**Issuing Entity:**  
Dartron Industries, Inc

## PRODUCT IMPROVEMENT BULLETIN

<b>Ride Manufacturer:</b> Dartron Industries, Inc.	<b>Affected Production Dates:</b>
<b>Ride Name:</b> StarTrooper	<b>Affected Serial #'s</b> 111141-5S
<b>Model #</b>

**Abstract of Issue:** StarTrooper bushing change

# BULLETIN #935

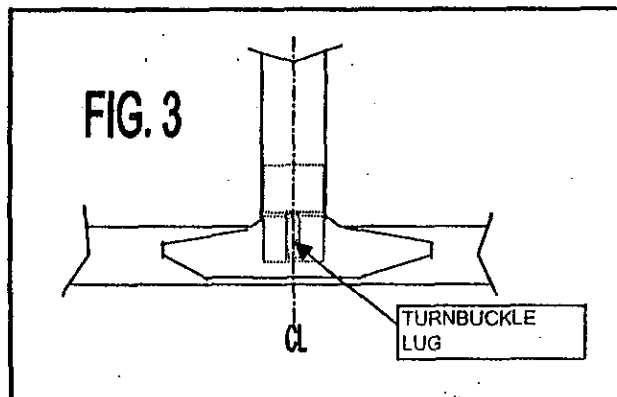
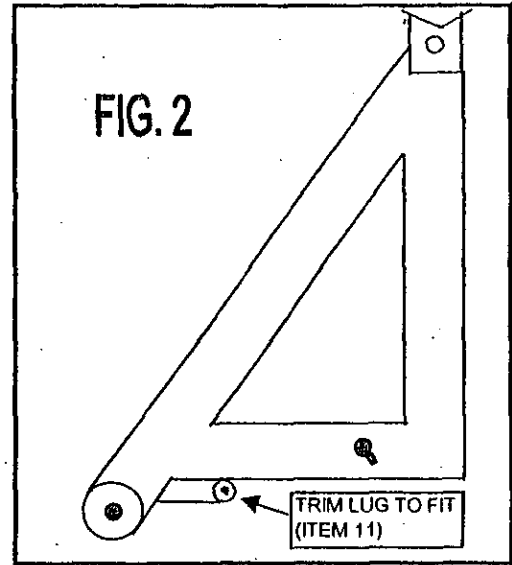
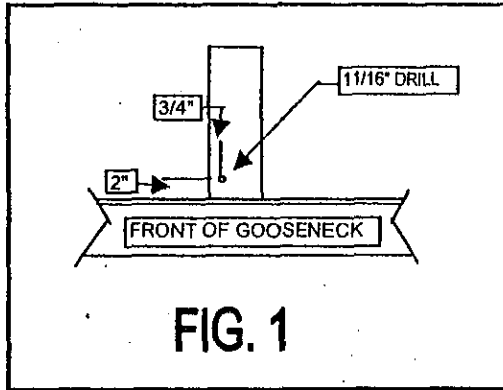
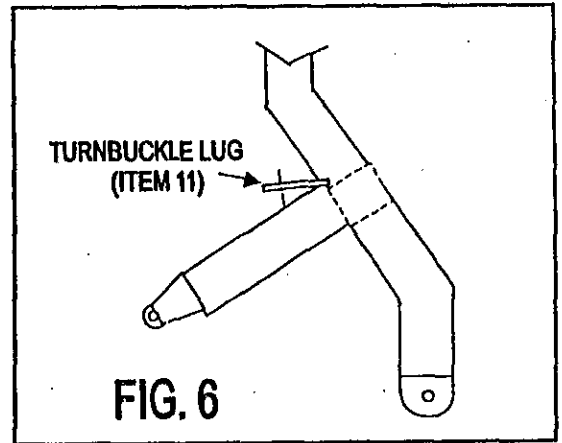
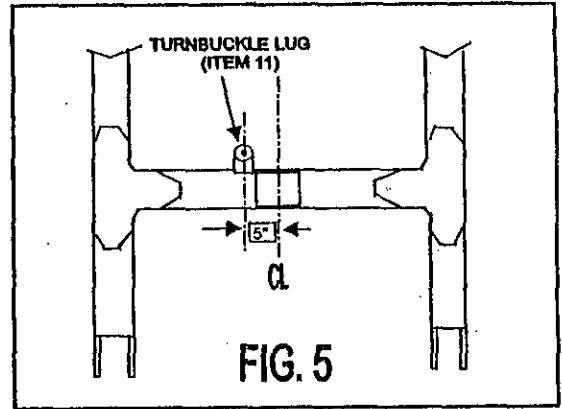
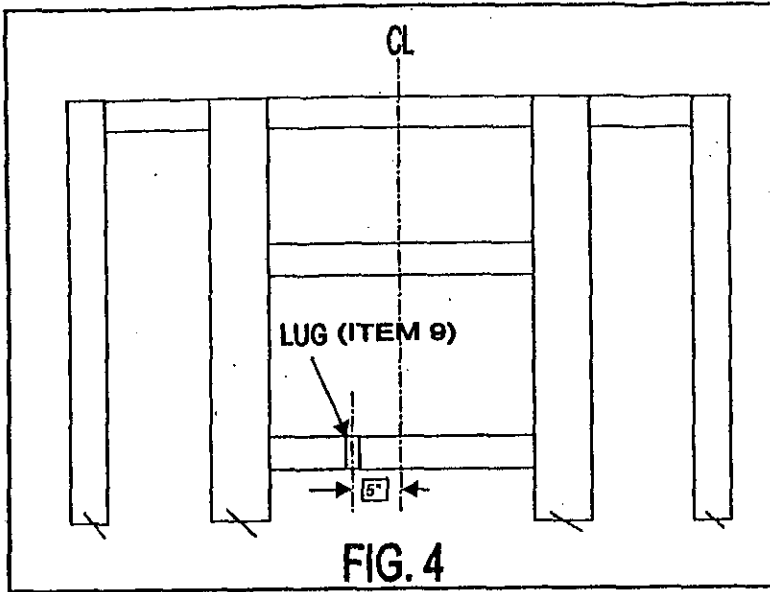
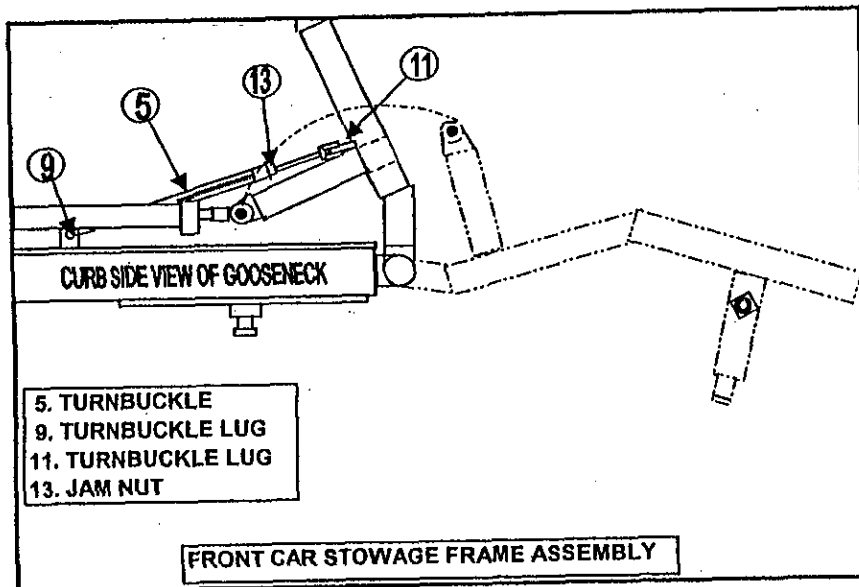
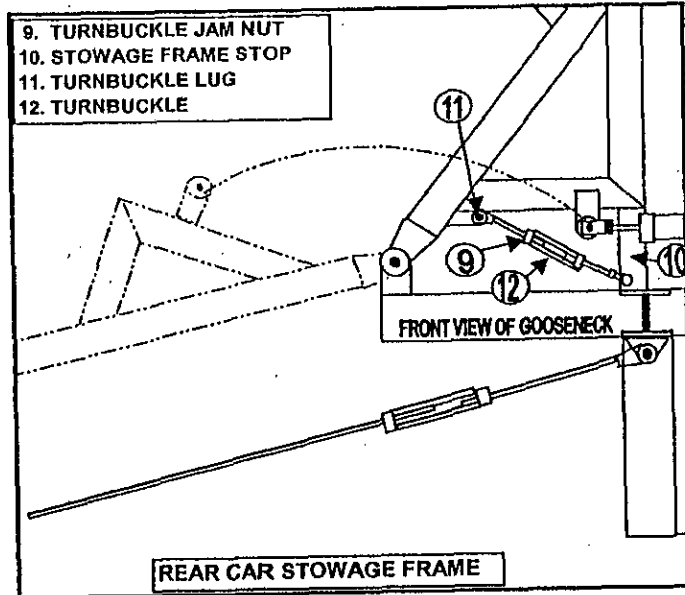
**Action to be taken:** It has come to our attention in the event of a failure of the hydraulic system holding the carracks in position, if the safety chain is attached loosely, the safety rack could fall to the lowered position and cause the chain to break. Because of this possibility Dartron has developed a turnbuckle holding device that will ensure that the storage racks cannot drop to the unload position in the event of a hydraulic failure. Until the turnbuckle kit is installed, you must wrap a cargo strap or chain or similar device around all three car storage racks as a precaution against a hydraulic failure causing the racks to lower to the unload position.

1. Drill an 11/16-diameter hole in storage frame stops on trailer gooseneck (fig 1).
2. Trim supplied turnbuckle lugs (item 11) to fit storage frame (fig 2).
3. Establish centerline of frame. Weld turnbuckle lug (item 11) on center (fig 3).
4. Install short turnbuckle (item 12) with jam nut end (item 9) toward storage frame; install pin with R key. Install trailer side turnbuckle endpin; secure with cotter pin.

1. Unbolt and remove deck plate located at front of trailer.
2. Measure and locate centerline of trailer gooseneck. Mark center on cross member approximately thirty inches from front of trailer. Measure five inches toward left (street) side of trailer and mark. Weld turnbuckle (item 9) lug to cross member on mark (fig 4).
3. Weld supplied brace in cross member (structural channel) directly under turnbuckle lug.
4. Trim deck plate (item 9) to fit and reinstall.
5. Raise front storage frame to full upright position.
6. Measure storage frame and mark centerline. Measure five inches toward left (street) side and mark (fig 5).
7. Measure and mark center line of turnbuckle lug. Center lug on mark and tack in place. Install long turnbuckle and check fit. Weld permanently (fig 6).
8. With jam nut towards storage frame and pins installed, secure with cotter pin and R key.

**FIG. 1**

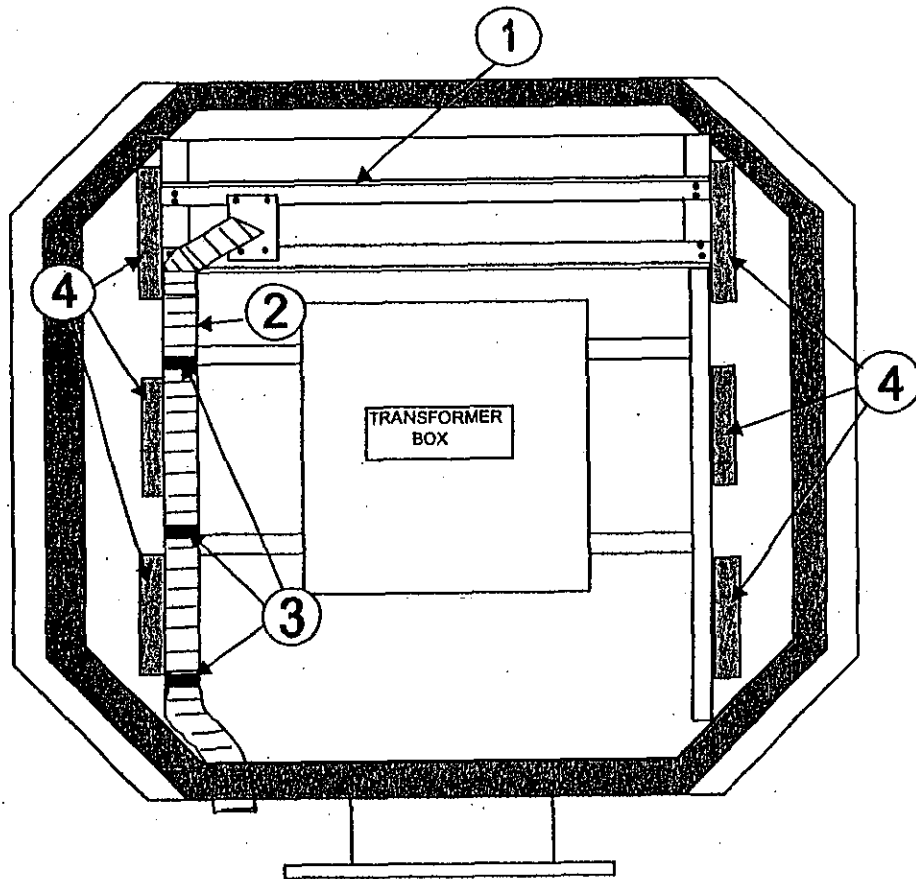
- 1 Disconnect power to center ornament.
- 2 Remove ornament panels.
- 3 Remove upper ballasts located in structural channels above and to sides of the electrical control panels (fig 1).

4. Fit fan motor housing assembly to structural channels with fan housing above lighting panel. Position as in (fig 1) and clamp in place.
5. Drill and tap holes to mount fan motor assembly drill size 13/64 tap 1/4-20.

6. Mount fan motor assembly with supplied bolts.
7. Drill and tap holes in structural channels for ducting mounting clamps (1/8 drill 8/32 tap) secure ducting to exhaust vent, attach to clamps on structural channel and run end of duct out bottom or ornament.

FIG. 2

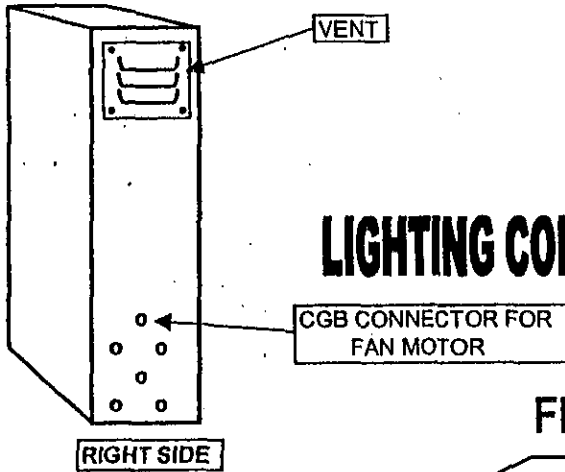
8. Drill 7/8" hole in right side of lighting control panel as shown in (fig 2) for CGB connector.
9. Wire in fan motor to lighting panel downstream of fuse or circuit breaker.

10. Locate position for vents on lighting control panel both right and left sides making sure there are no obstructions inside panel. Using supplied templates mark and drill holes in panel (fig 2 & 3)

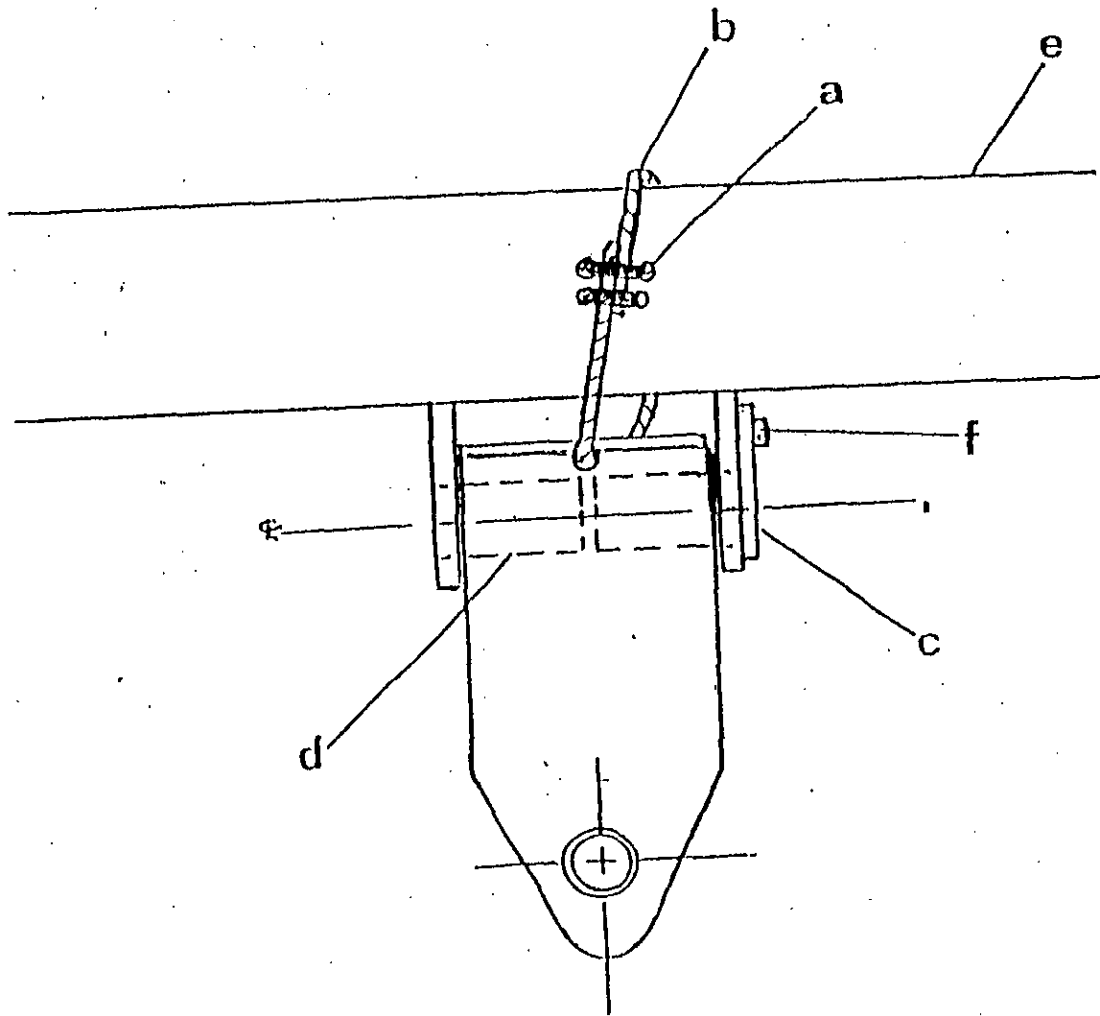
**Reason for release:** Because of a combination of factors, among them rough road conditions, one area of the StarTrooper lightning bolt sweep light cans is receiving a higher degree of stress than was expected. This can result in the partial failure of the welded joints, which could cause a lightning bolt to come off the ride during transportation or operation.

**Action to be taken:** Dartron Industries, Inc. requires that all StarTrooper's with serial #'s shown above inspect lightning bolt sweep light cans for structural cracks as shown in (fig 1). It is further recommended that all affected lightning bolt sweep light cans be reworked with the following reinforcement kit for added rigidity.

Bulletin No. 4039  
 Product: StarTrooper

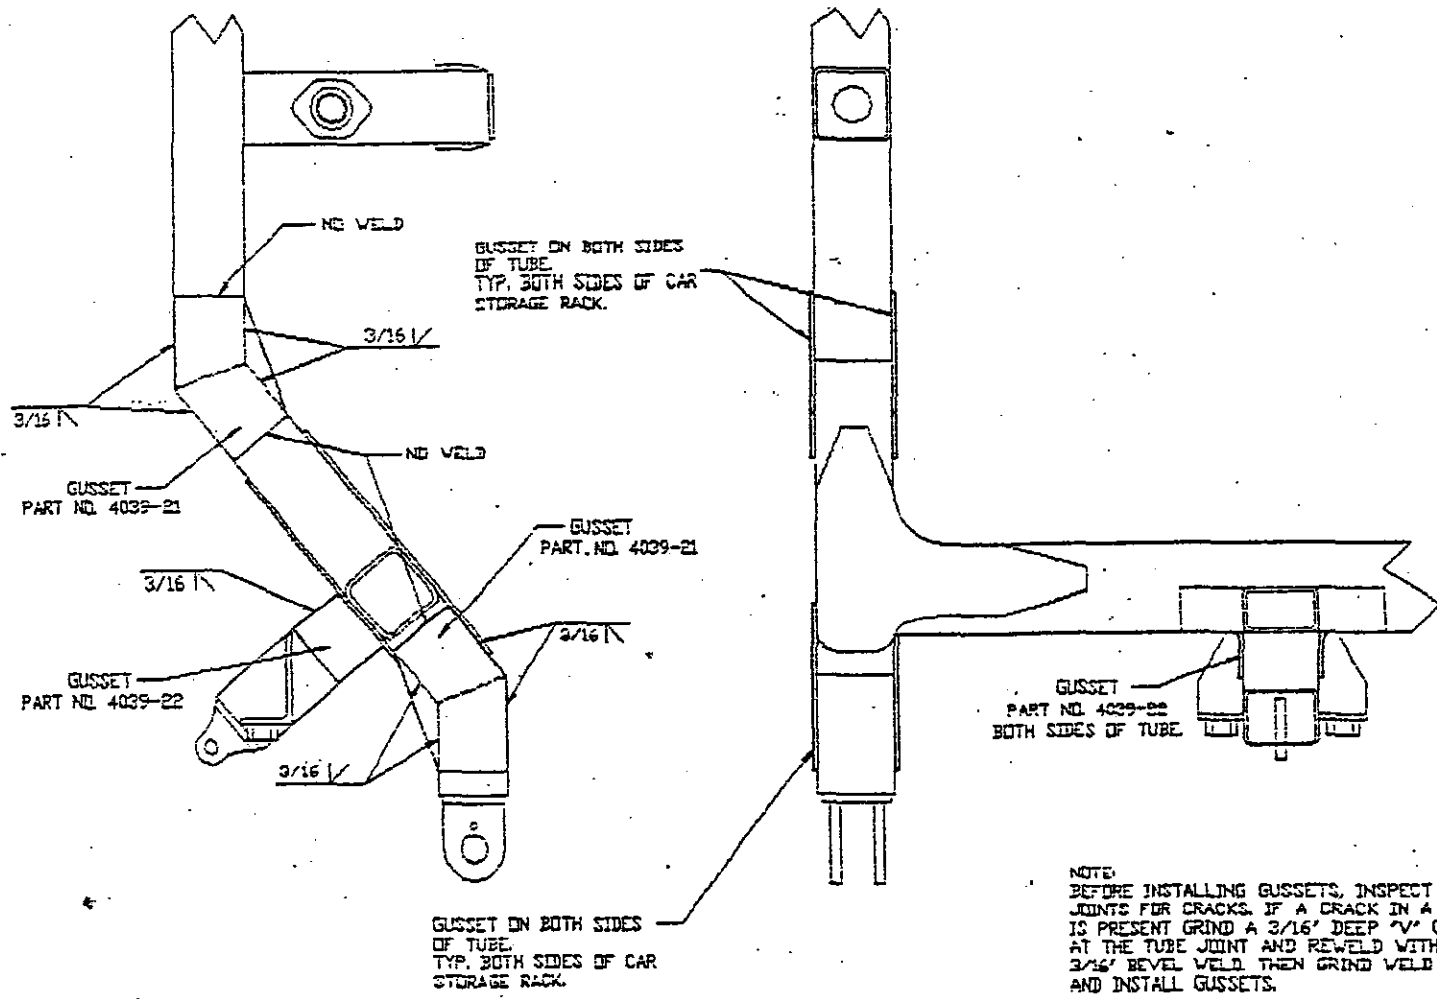
**Reason for release:** As a result of moving the StarTrooper long distances over rough roads, crack could develop in certain welded joints in the front car storage rack. If the cracks are not addressed, the joint could separate and cause the cars carried by this rack to drop during transit.

- Immediately inspect area shown on the attached drawings for cracking.
- If cracks are detected, immediately install gussets as shown in attached drawing.
- If cracks are not detected, gussets still must be added no later than March 1, 1996.

NOTE:  
 BEFORE INSTALLING GUSSETS, INSPECT TUBE JOINTS FOR CRACKS. IF A CRACK IN A JOINT IS PRESENT GRIND A 3/16" DEEP "V" GROOVE AT THE TUBE JOINT AND REWELD WITH A 3/16" BEVEL WELD. THEN GRIND WELD FLAT AND INSTALL GUSSETS.
